ALERT SERVICE BULLETIN

NO. 407-02-56

DATE December 5, 2002

SUBJECT: TAIL ROTOR BLADES 407-016-001-101 and 406-016-100-119 ONE TIME LEAK CHECK

Figure 1. Areas for particular attention during inspection

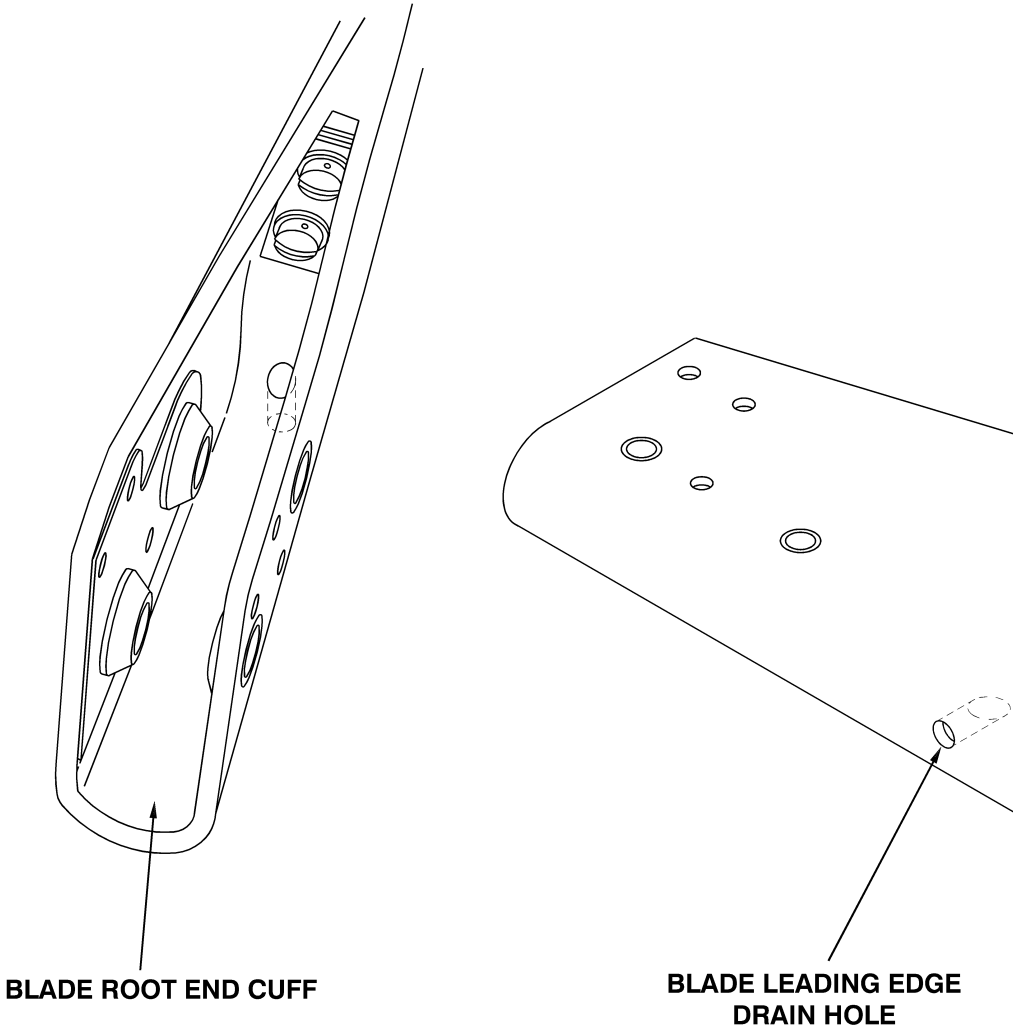
4. Wipe the blade dry and perform a thorough inspection of the blade. Look for any pin hole or bond line separation that could be the potential for water entry. Pay particular attention in the root end cuff and around the leading edge drain hole (Figure 1).

11. Gently rotate blade back and forth to allow a thorough inspection of all the blade surfaces. Pay particular attention to the root end cuff and around the leading edge drain hole. Refer to the Figure 1.

1. Repair any defect located in the blade root end cuff as follows:
 - a. Thoroughly clean the area around the leak point using aliphatic naphtha solvent (C-305). Do not allow solvent to enter the leak point. Wipe dry with a clean lint-free cloth.
 - b. Apply sufficient AMS-S-8802 sealant (C-308) to the leak point to completely seal the defect. Sealant should extend a minimum of 0.250 inch around the defect in all directions.
 - c. Cure the sealant per manufacturer's instructions.
 - d. Do the leak check again as per PART II c. of this bulletin after the repair to ensure the blade does not leak.
 - e. Prime and paint touch-up the repaired area is optional.

2. Repair any defect located on the exterior surface of the blade or in the leading edge drain hole as follows:
 - a. Sand the area to be repaired by hand with 220 grit sand paper. Do not sand into the fiberglass.
